**ADDENDUM NO. 03 – May 13, 2024**

**RE: Abatement of the Interior of the Stone Building  
Augusta, ME  
GALE JN: 839100 Phase 01 Task 03  
BGS Project Number 3381**

**Figure 4**  
Basement Area

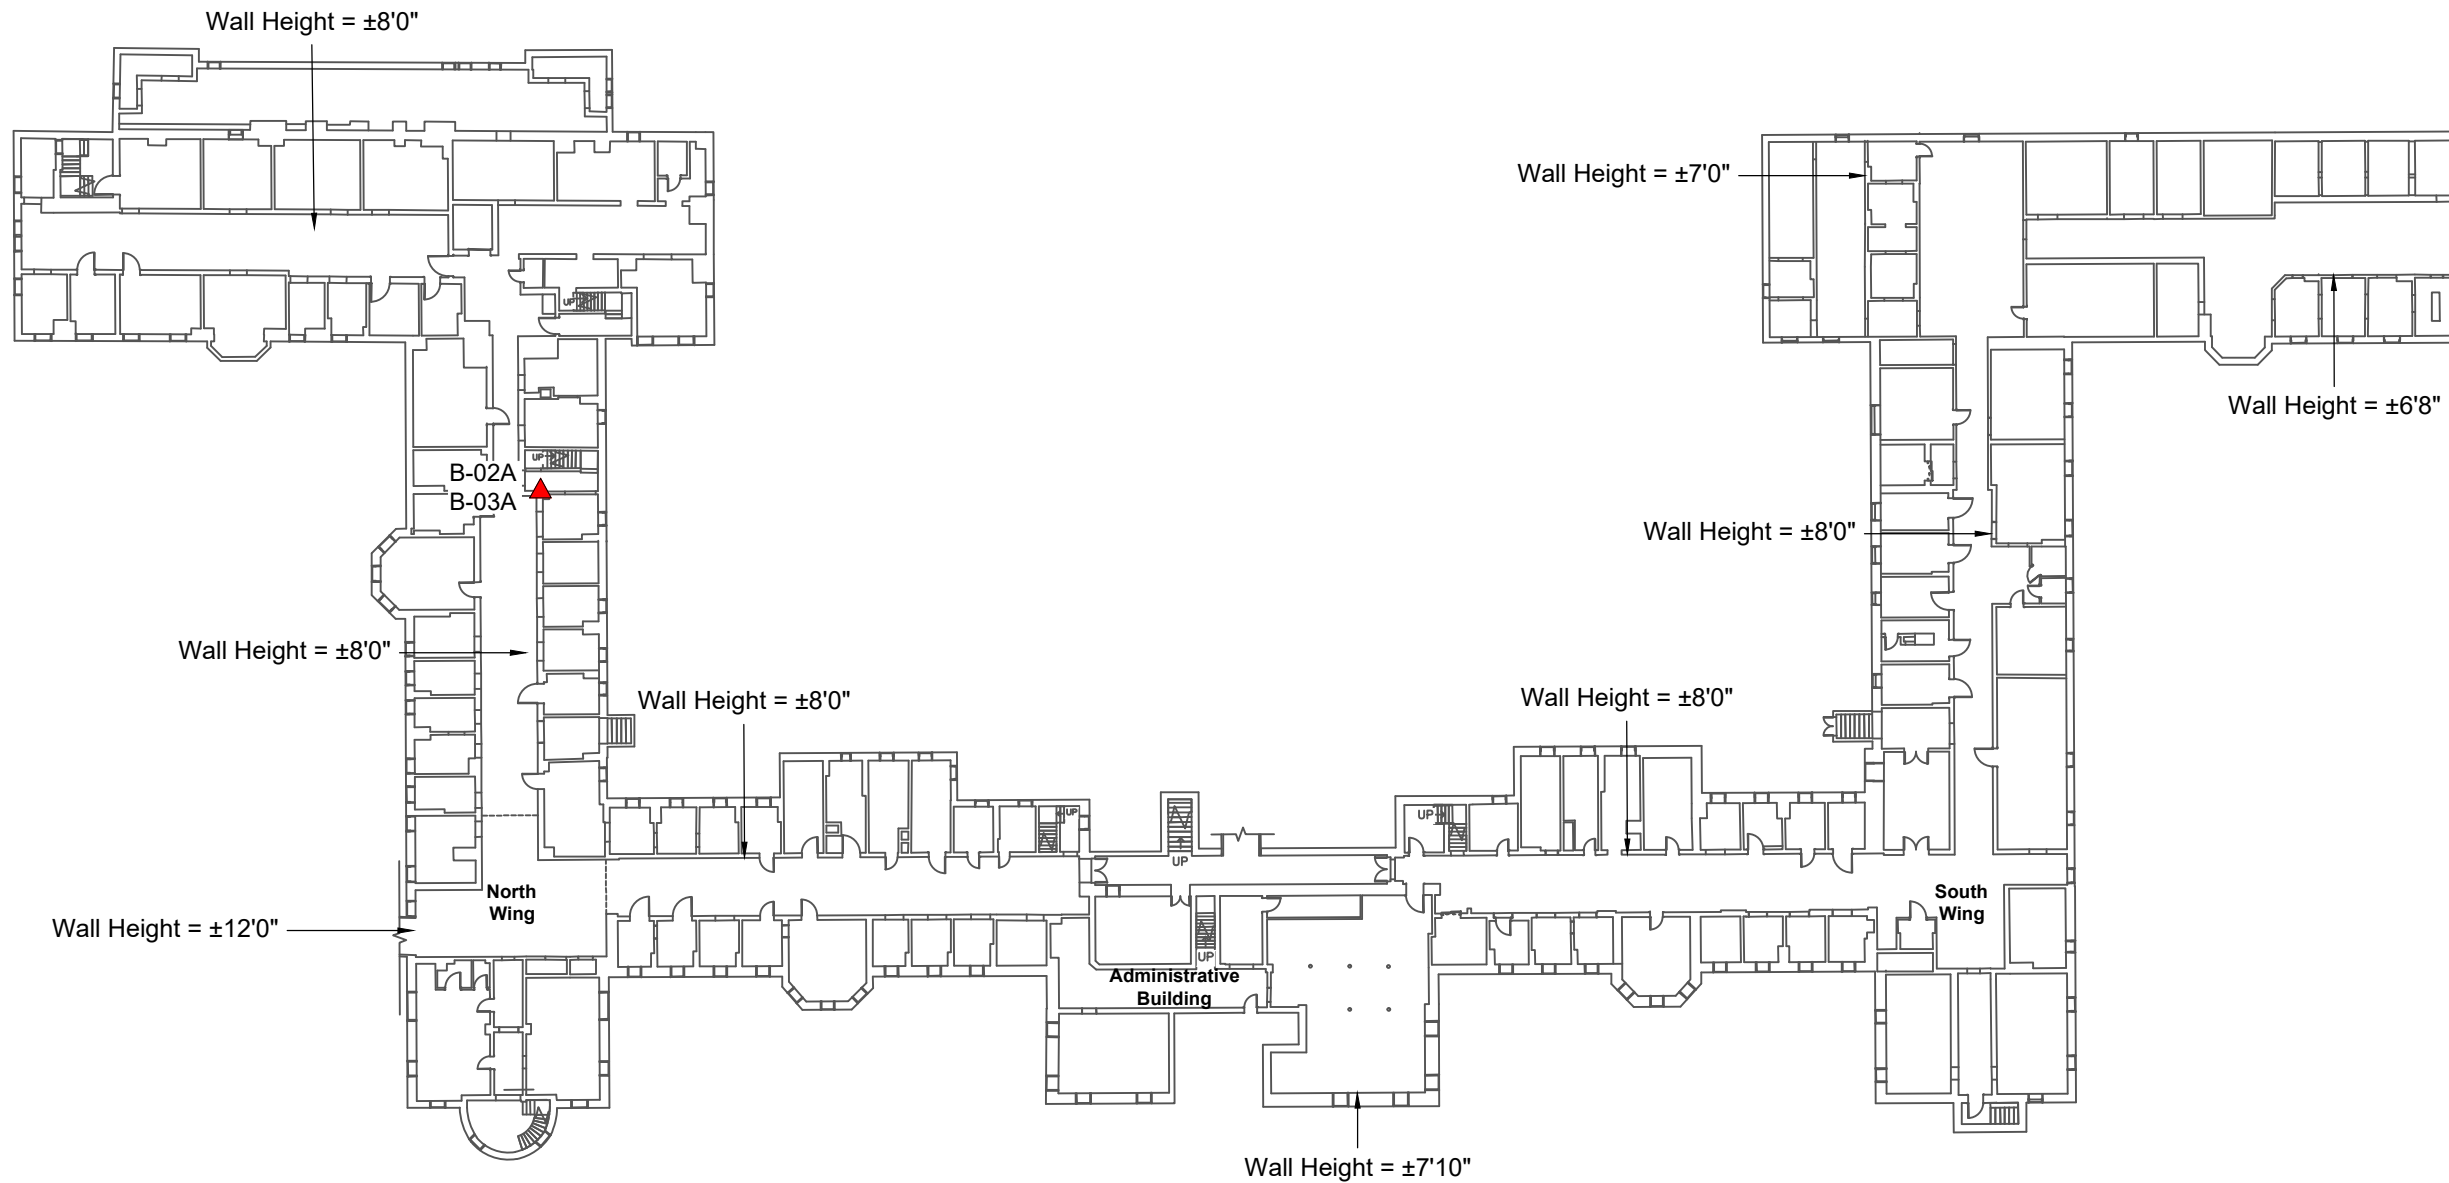
Question: Please issue a floor plan for the basement level indicating where the asbestos abatement work starts and stops

Question: There does not appear to be any lead testing results from AQM at the basement level. How much lead removal should we include at the basement level? Please issue a floor plan for the basement level indicating where the lead removal work area starts and stops.

Question: Is the pipe insulation in the basement/tunnel areas included in this bid?

Substitution: An updated Figure 4 has been provided. The areas shown on the updated Figure 4 are the areas included in this scope of work.

Clarification: The bid specification has been modified to indicate removal of paint from 100% of exposed surfaces down to bare substrate regardless of lead content. Painted surfaces in the

basement area include walls and ceiling. Figure 4 has been revised to provide approximate wall heights and scale for estimation purposes.

Clarification: Yes, pipe insulation in the basement of the Stone Building that tested positive, or was labeled/presumed positive for asbestos is included in this bid. The revised Figure 4 provided with this Addendum shows the areas of the basement that are included in this bid. Areas not shown on Figure 4 are not included in the scope of work.
